Access Compliance Report

Public Rights-of-Way

Intersection ID: 14340	Main Street: GREENWOOD_CLIFF	Cross Street: KENILWORTH_AV	Location: E
ADA ID: 214D3C248ED1	Ramp Type: Perp	Initial Pass/Fail: Pass	Overall Compliance: No
			Severity Score: 17.75

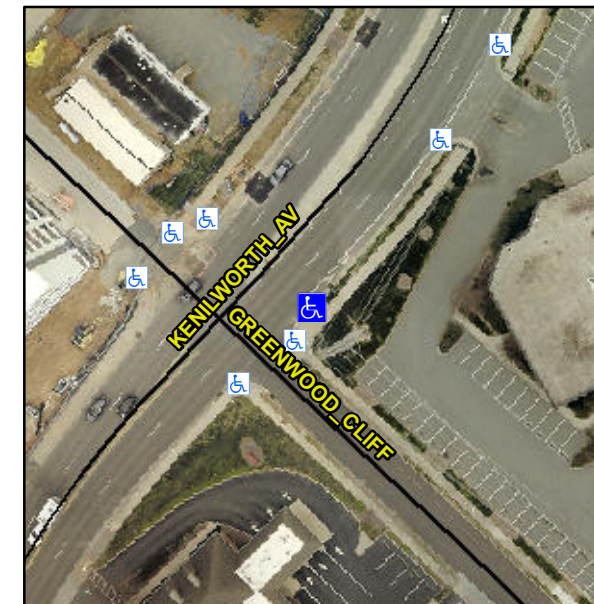
**Not Found, R304.5.3, R304.2.1,
R304.2.2-Perp, R304.3.2-Para,
R304.2.3, R304.5.4**

Compliance	Description	Data	Compliance	Description	Data
N/A	Ramp Length (in)	120.0	Yes	Ramp Slope (%)	7.5
Yes	Ramp Width (in)	48.0	No	Ramp XSlope (%)	4.5
N/A	Flare Type LT	Sloped	N/A	Flare Type RT	N/A
N/A	Flare Slope LT (%)	4.8	No	Flare Slope RT (%)	11.0
N/A	Flare Traversable LT?	Yes	N/A	Flare Traversable RT?	Yes
No	Landing Length (in)	N/A	Yes	DWS Provided?	Yes
No	Landing Width (in)	N/A	Yes	DWS Contrast?	Yes
No	Landing Slope (%)	N/A	Yes	DWS Length (in)	24.5
No	Landing X Slope (%)	N/A	Yes	DWS Full Width?	Yes
N/A	Landing Curb? (Y/N)	No	Yes	DWS Offset (in)	0.0
N/A	Shared Landing?	No			
Yes	Gutter Ponding?	No	No	Gutter Slope (%)	6.9
Yes	Gutter Lip Ht (in)	0.0	No	Gutter X Slope (%)	3.3
N/A	Painted X Walk1?	No	N/A	Painted X Walk2?	N/A
	X Walk 1 Direction	To NW		X Walk 2 Direction	N/A
N/A	X Walk 1 Width (in)	N/A	N/A	X Walk 2 Width (in)	N/A
	X Walk 1 Slope (%)	1.3		X Walk 2 Slope (%)	N/A
	X Walk 1 X Slope (%)	2.7		X Walk 2 X Slope (%)	N/A

**Remove & Replace Entire Ramp.
Remove & Replace Gutter.**
